**Re: Petition Requesting Administrator to Object to Part 70 Operating Permit
Modification LDEQ No. 0560-00214-V3 Sabine Pass LNG Terminal
(Cameron Parish, LA) LDEQ Agency Interest No. 119267**

**PETITION REQUESTING THE ADMINISTRATOR TO OBJECT TO THE PART 70
OPERATING PERMIT MODIFICATION NO. 0560-00214-V3 ISSUED TO SABINE
PASS LNG, LP AND SABINE PASS LIQUEFACTION, LLC**

Re: GCELC Written Comments on Draft Part 70 Air Operating Permit Modification and Prevention of Significant Deterioration (“PSD”) Permit Modification of the Sabine Pass Liquefied Natural Gas (“LNG”) Terminal (Cameron Parish, LA) (AI Number 119267, Permit Number 0560-00214 V3 and PSD-LA-703(M3), and Activity Number PER20100002)

Figure V.B.1 – Freeport LNG Compression Project Thermal Treatment Diagram for Acid Gas Vents

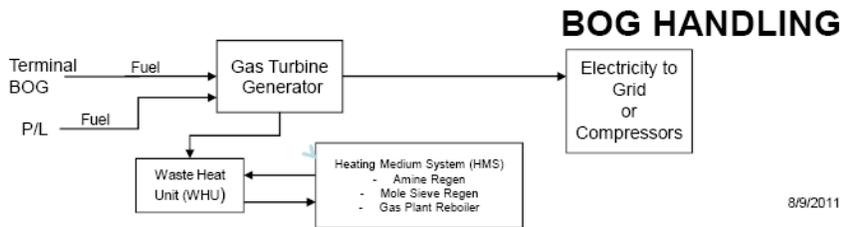
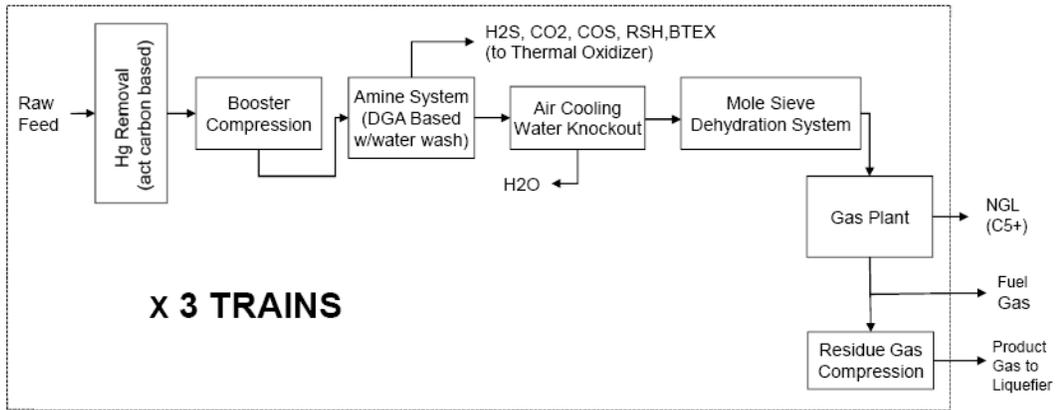
The use of a thermal oxidizer (“TO”) to control emissions from the amine system is another control technology identified as BACT in the Freeport LNG Liquefaction Project permit application that was not considered in the Sabine Pass LNG Terminal permit application or the LDEQ public record. While LDEQ is permitting the free-venting of the emissions from the amine system, the Freeport LNG Liquefaction Project permit application proposes use of a TO for control of these emissions. The Freeport LNG Liquefaction Project permit application also includes a diagram that notes the TO is required to control emissions of H₂S and BTEX. This illustrates a gap in control for the Sabine Pass LNG Terminal modifications and confirms the contentions of GCELC that these emissions are significant (*see* section II.A.1 *supra* at 14-17) and may be controlled via BACT. Figure V.B.1 below shows the TO for control of BTEX, H₂S and other reduced sulfur compounds in the upper center of the diagram for the pretreatment system:
